Adamstown Station District Centre, Co Dublin  
Masterplan - Phase II - Block G

Application for Amendments to Block G  
REQUEST FOR FURTHER INFORMATION | FEBRUARY 2022

REQUEST FOR FURTHER INFORMATION

RFI no. 1. (c)

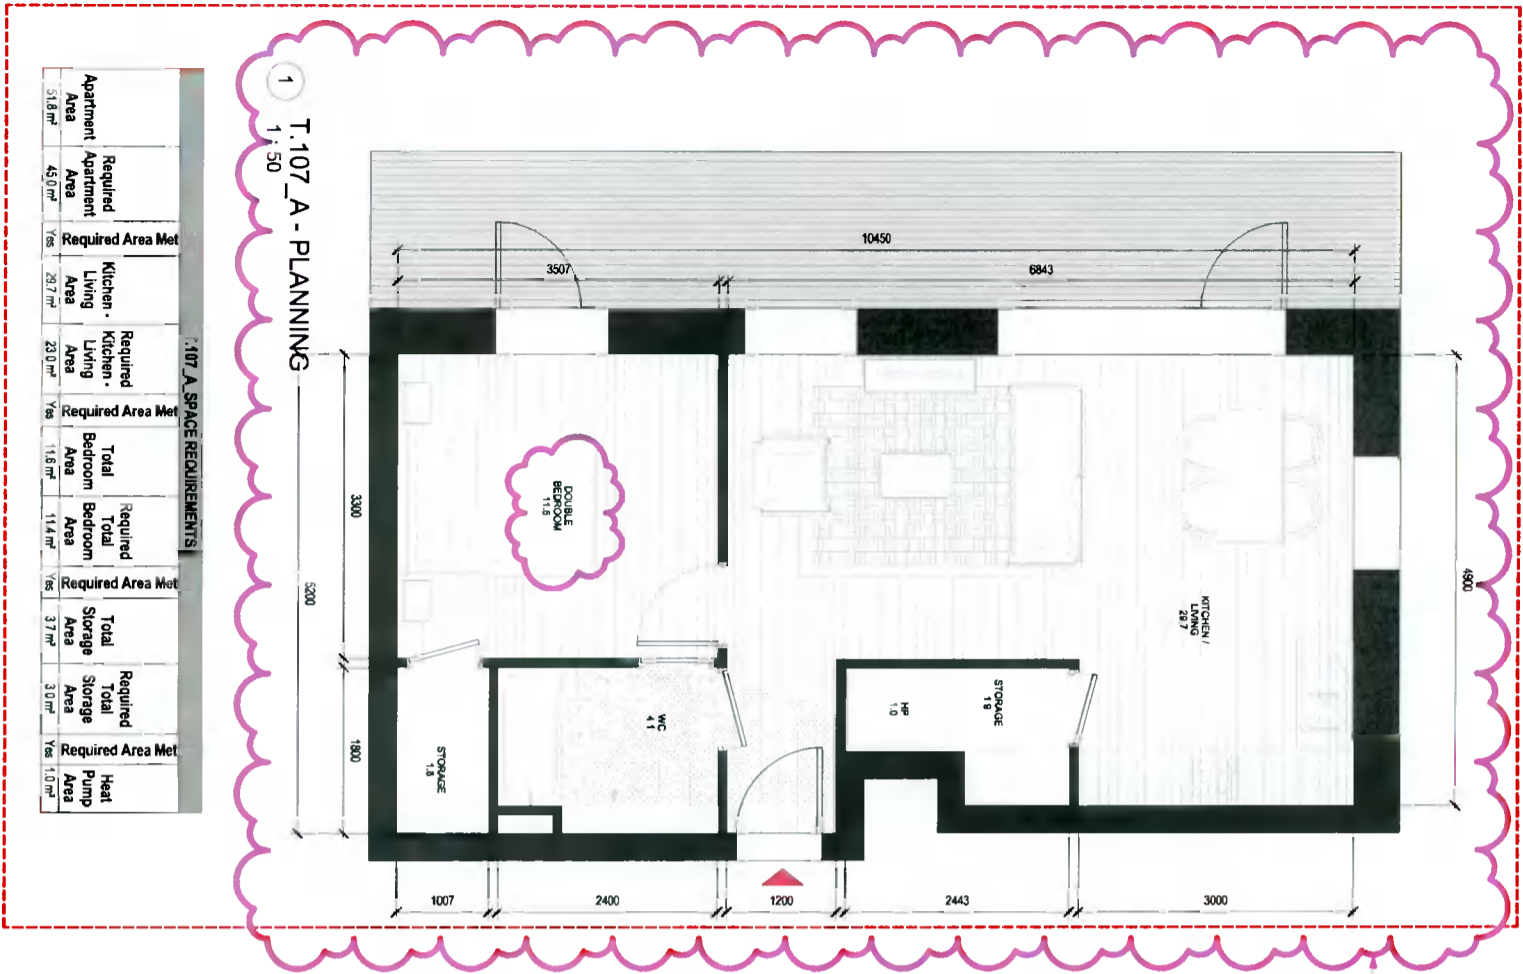
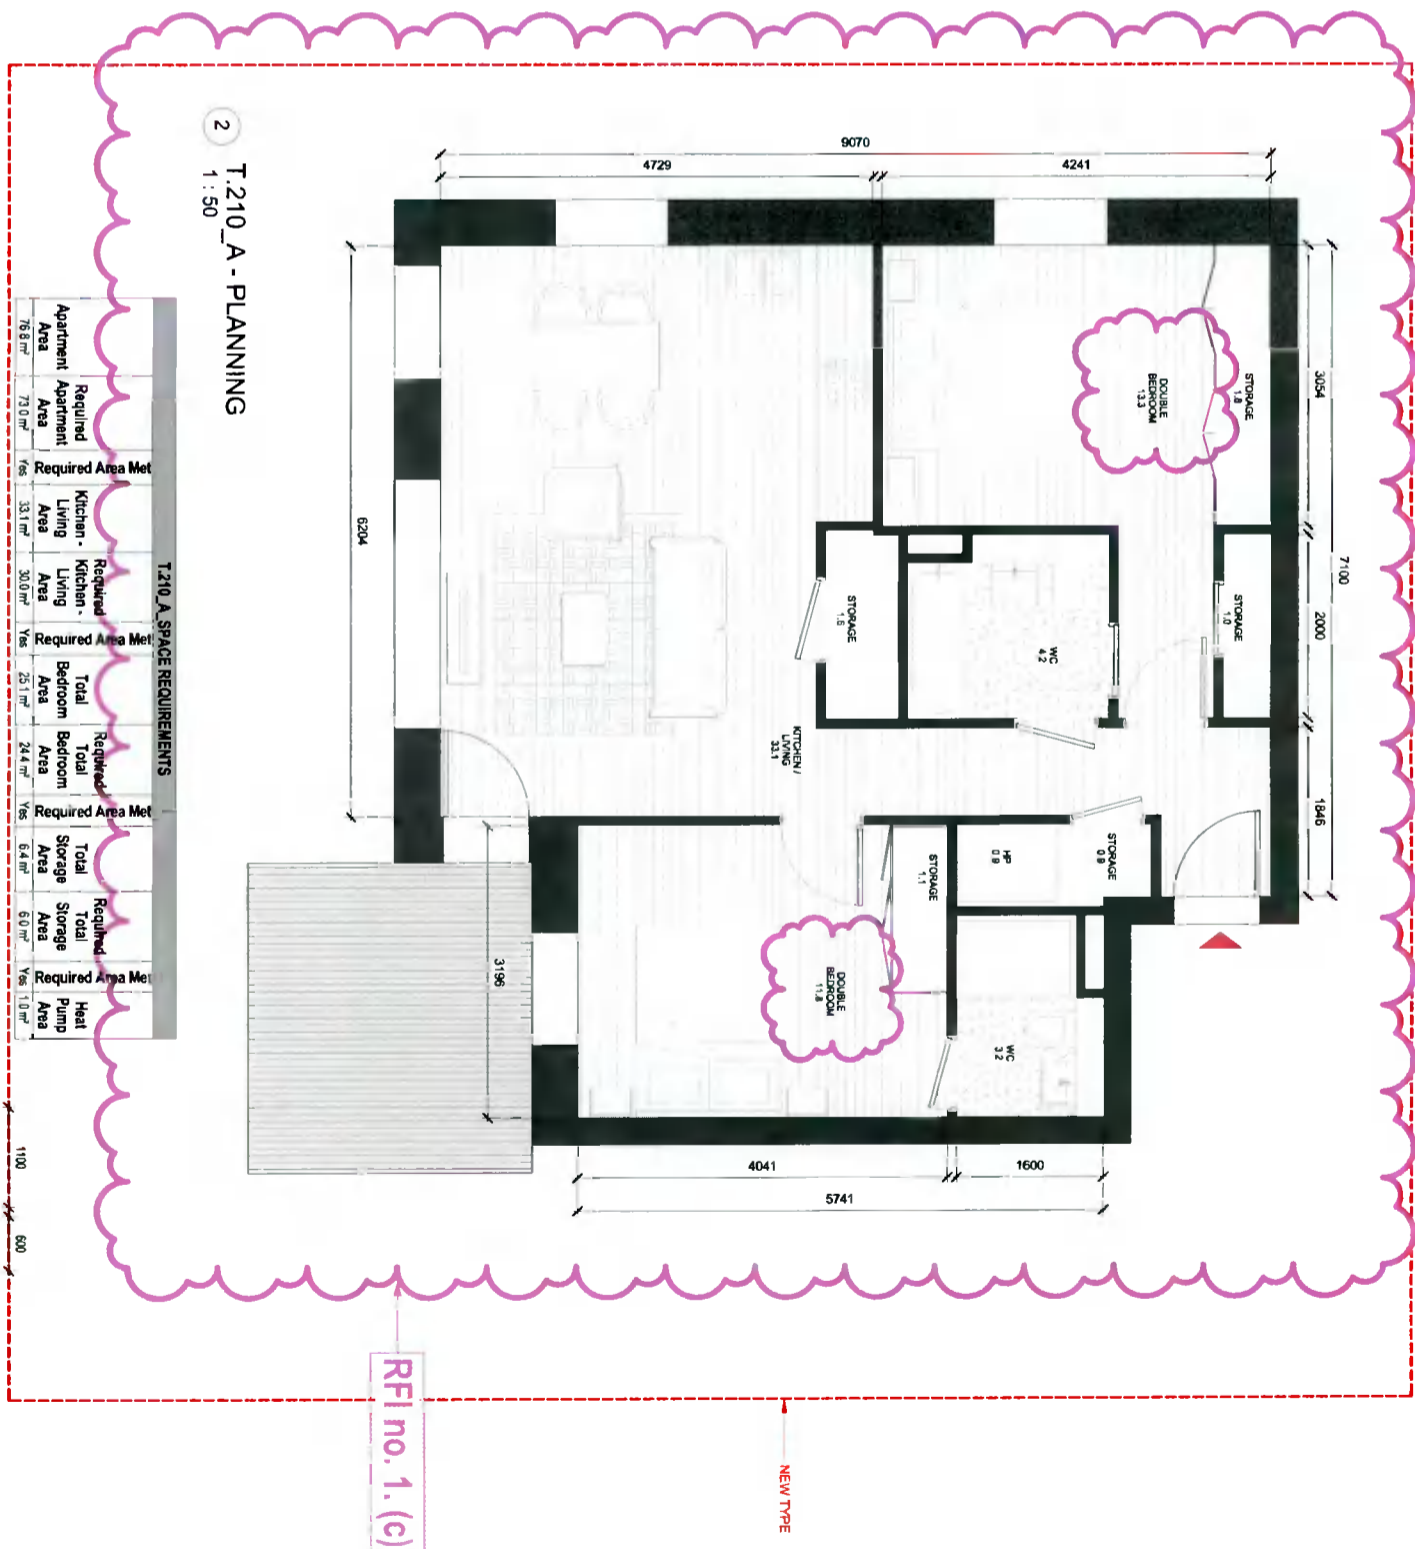
1. (c) Resizing of five apartments proposed at fifth floor level in Block G2 (G2S.501 and G2S.505). The apartment schedule indicates that these meet the minimum aggregate areas and it is apparent that they meet the minimum widths for living areas and bedrooms. Apartment no. 501 is a 1 bed 2 person apartment and 505 is a 2 bed 4 person apartment. The applicant is requested to clarify that the bedrooms in these apartments meet the minimum 11.4sq.m requirement for bedroom size (Note: Minimum floor areas exclude built-in storage presses that are contributing to storage space).

Confirmation of the minimum set bedroom areas achieved in the bedrooms highlighted is outlined on the subsequent page.

APT Q2S.501 IS T.107\_A - HQA STATES 11.6SQM AND DRAWING 8002 STATES 11.6 SQM - REFER TO DRAWING 8002, T.107\_A

APT Q2S.505 IS T.210\_A - HQA STATES 25.1 SQM COMBINED BEDROOM AREA (COMPLIANT) AND DRAWING 8005 STATES 13.3 SQM FOR MAIN BEDROOM AND 11.8 SQM FOR SECOND BEDROOM - REFER TO DRAWING 8005, T.210\_A

DRAWING: EASTWEST PEDESTRIAN ACCESS DESIRE LINES

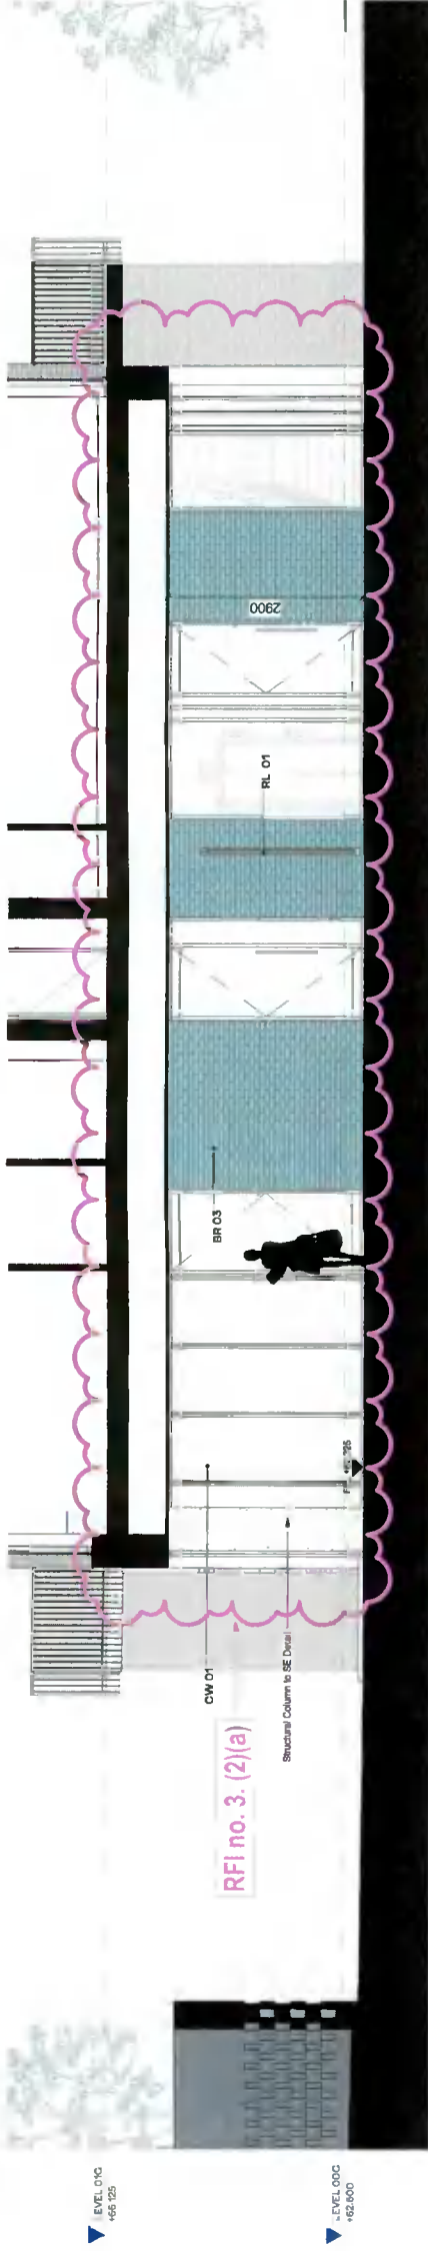
3. The ground floor layout for the entirety of the Block G tile has been amended substantially. The under-podium car parking has been relocated to an 'off-site' location. An east-west pedestrian access is proposed through Block C1 via an indistinguishable façade, (narrow and located alongside a waste facility). This link will have the important and crucial role acting as the primary link between the relocated car parking proposed in Block F and the heart of the Tile G (Blocks C1 and C2). The Planning Authority has reservations about this aspect of the proposal. This development will look westward for all its functions and needs. Therefore, any proposed east-west link should be expected to clearly demonstrate a safe, highly functional, well looked and comfortable pathway for all users in a westerly direction and be highly legible; it is not considered that this is achieved in the current proposals. The applicant is requested to:

(1) Clearly show, on plan, the pedestrian link between the car parking on the third floor of Block F to various locations within blocks C1 and C2. This plan should show true desire lines for pedestrians (i.e. lines that pedestrians will take and not those they will be corralled to take) for example show desire lines where they would cross the western north-south street once exiting the exit doors from Block F, and overlay these onto 'Junction - Location Plan'. Once the desire lines have been overlaid onto the 'Junction - Location Plan' the Planning Authority request the design team to modify the proposals and layout to incorporate more direct routes to the Block G development from the District Centre in general and the car parking in Block F specifically (with particular reference to the most direct routes to both the entrances at 1) the east-west penetrator in the western block and 2) the south-west entrance.

This may require the relocation of pedestrian crossing/significant raised tables/change in street materials or changes in the location of the proposed pedestrian access in Block C1. Of significant concern is the vehicular access to Block F, which appears to be situated at an important movement pathway that links Blocks C with activities associated with the wider District Centre. In this regard, the red line of the boundary as shown in the Site Layout Plan may need to be increased to incorporate these required works.

(2)(a) The east-west penetrator located in the western block (Block C1) connecting the north-south link street into the communal open space should be redesigned to provide greater legibility and should be strengthened to create a more functional through-way. As a minimum the entrance should be significantly widened and should incorporate design features that will make this important connection point more welcoming and legible.

(b) The waste facility room at the east-west penetrator in Block C1 should be significantly redesigned, to provide for a much-widened pedestrian connection or alternatively should be fully relocated.

Significant redesign to the ground floor configuration of the northern half of Block C1 has resulted in a more highly functional and permeable layout.

Now serving as the primary external entrance to the courtyard, the east-west pedestrian access is repositioned to align with the western movement pathway connecting Block C to Block F pedestrian lift cores, and to the heart of 'The Crossings' tile beyond.

In it's proposed location, the passage will serve as a highly active and communal through-way. It becomes an efficient multi-use feature allowing residents to flow freely and gain direct access to Core C1-N, the concierge, amenity space, communal garden and Block G2. At this intersection, an opportunity for a secondary outdoor amenity space is created within the northern half of the courtyard. Here, residents can avail of a south facing landscaped space adjacent the residential amenities.

RFI no 3 (1)  
 TRUE DESIRE LINE FROM BLOCK G TO THE CROSSINGS

RFI no 3 (1)  
 DEDICATED SECURE PEDESTRIAN LIFT TO RESIDENTIAL CARPARKING SPACES IN BLOCK F

RFI no 3 (1)  
 ON STREET CAR PARKING PROVIDED FOR STREET FRONTING OWN DOOR UNITS

RFI no 3 (1)  
 PRIMARY DESIRE LINE IS ACCESSIBLE FROM VARIOUS LOCATIONS WITHIN G1 & G2 VIA COMMUNAL COURTYARD (CORES G1 & G2), G1-N, G2-S, G2-N AND COURTYARD SIDE OWN DOOR UNITS

2 Northern Bicycle Store - West Elevation  
1:50

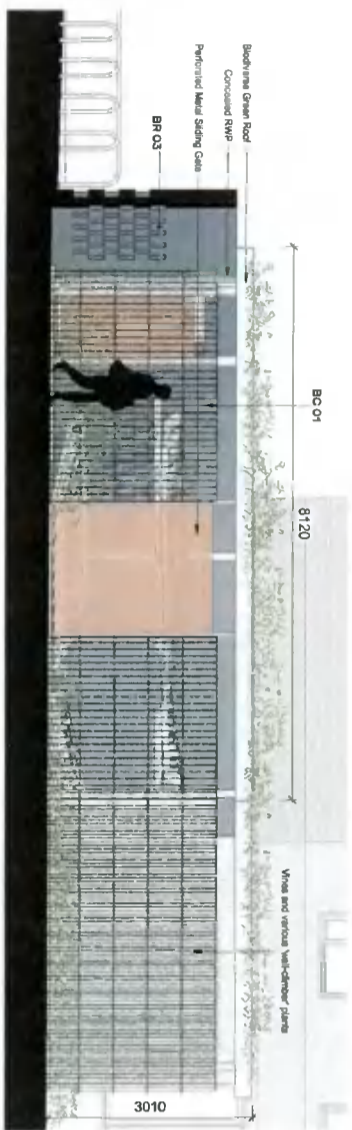
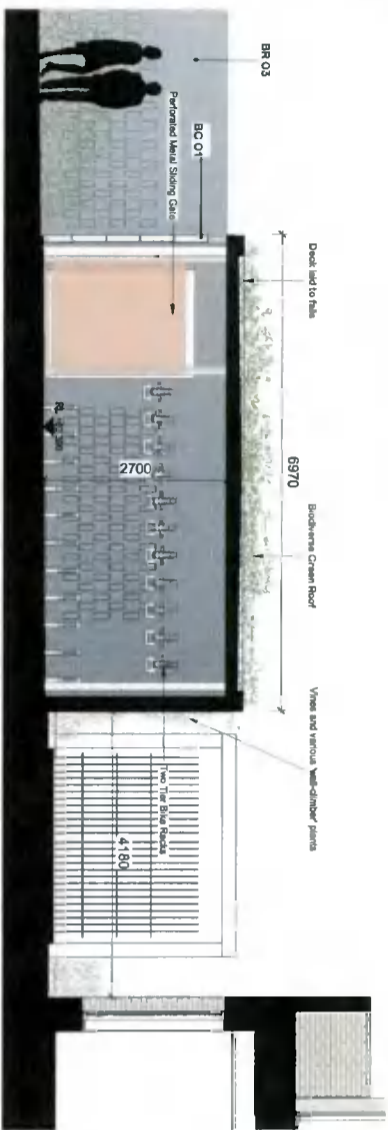
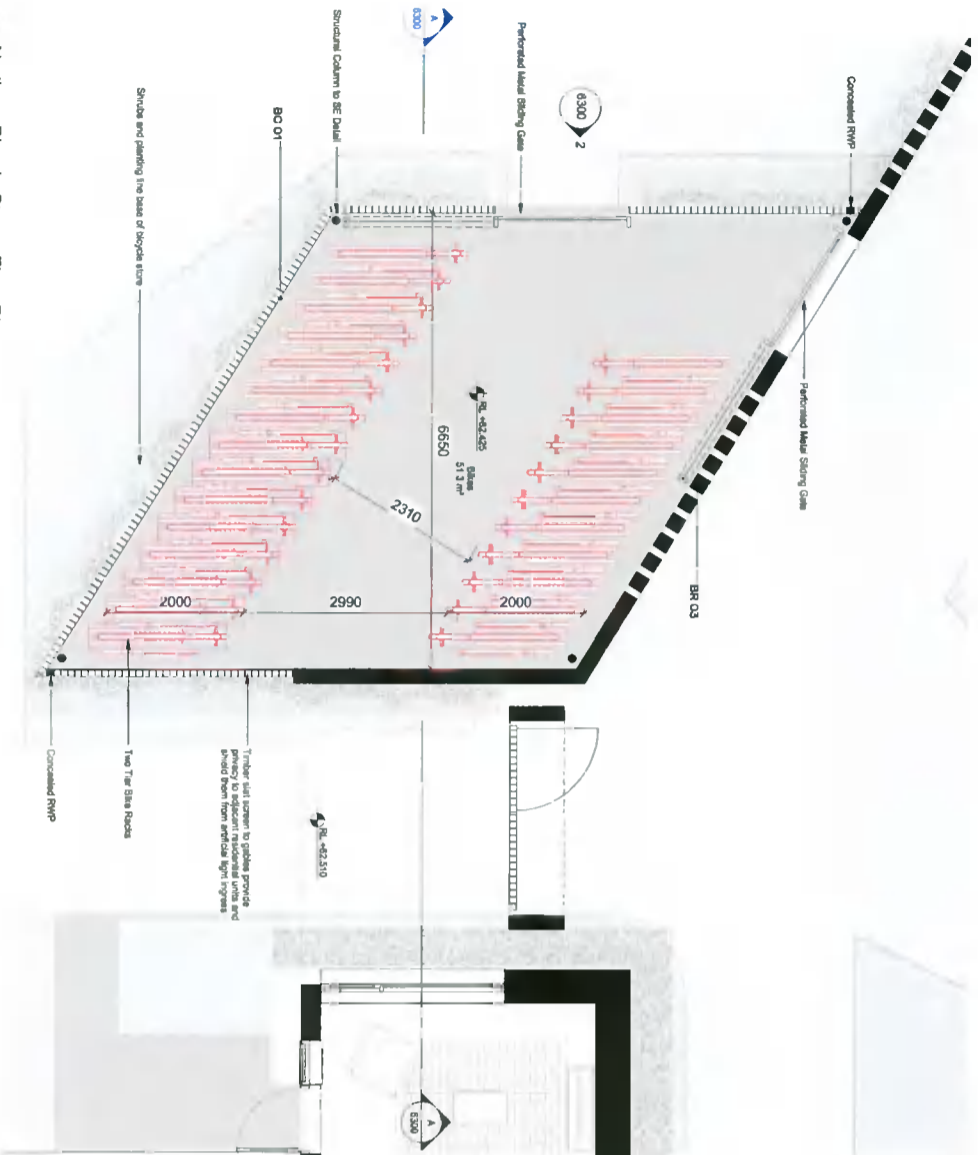
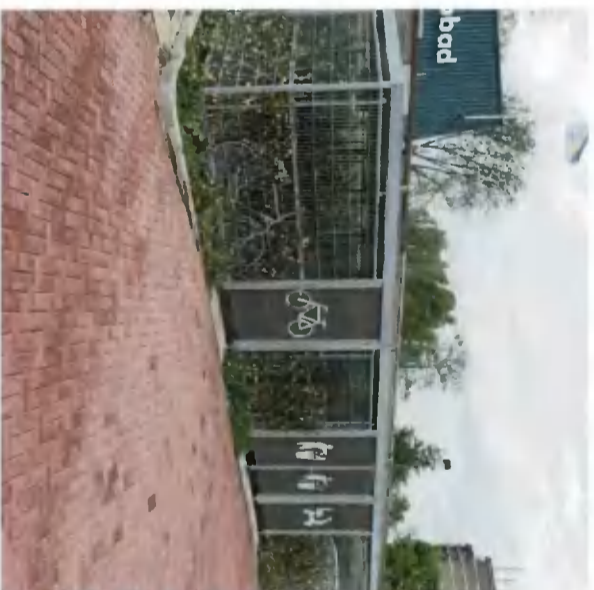
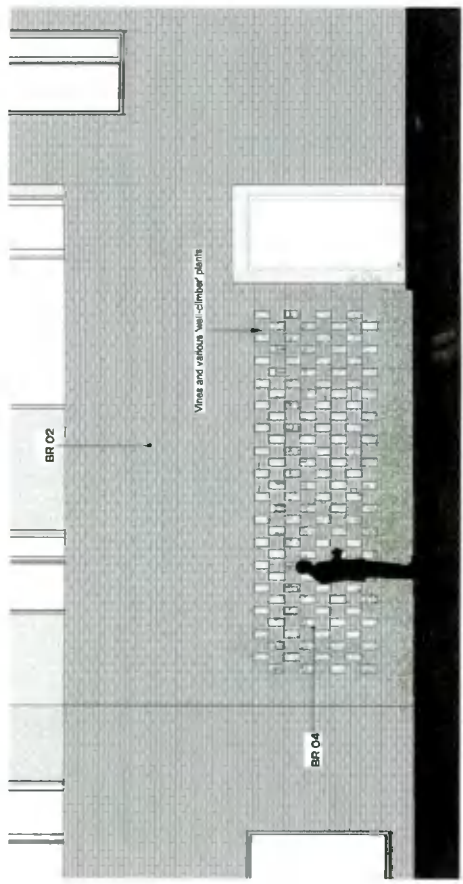
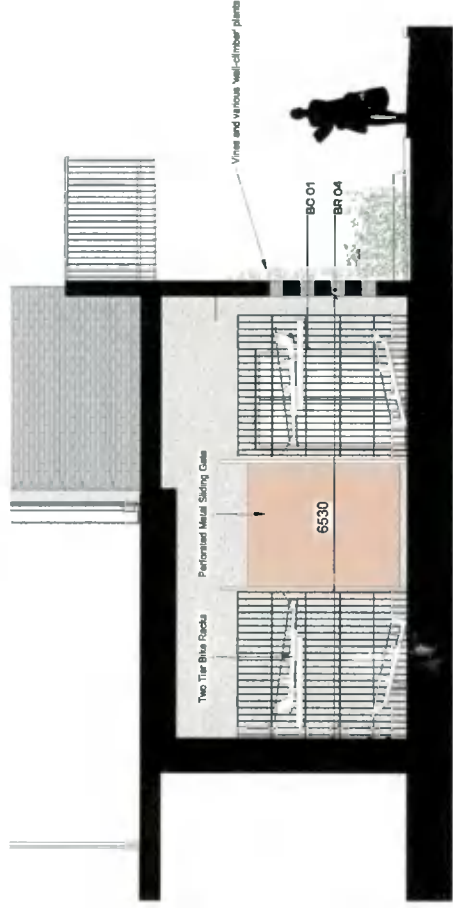
4. *The most northerly located bicycle parking structure (measuring approximately 79.95sq.m) is considered to be substantial and will dominate the northern end of the open/communal space. An alternative location should be sought for this bicycle storage. The applicant should investigate the incorporation of all bicycle storage within the building blocks/built fabric (similar to waste storage) and possibly omit an apartment to accommodate bicycle parking. If this is not possible, the applicant is requested to provide a sustainably 'greened' structure incorporating natural planting and green solutions within the design.*

Rearrangement of the east-west external link has allowed for the inclusion of a bicycle store within the built fabric of the building.

Combined with the marginal increase in size to the southern bicycle store, the bicycle shelter to the north of the courtyard is now greatly reduced by 37%, totalling an area of only 51sqm.

This new store is folded into the fabric of the courtyard perimeter, tucking itself into the angled brick garden wall and therefore apportioning more usable space to the landscape proposal.

A 'green' bike shelter is proposed for all three stores. Vines, shrubs and wall climbing plants help to soften the structures and blend them within the communal garden.

Other sustainability and aesthetic considerations have also been incorporated via the inclusion of a pollinator friendly, biodiverse green roof finish proposed to the roof decks of the 2 external bike stores.
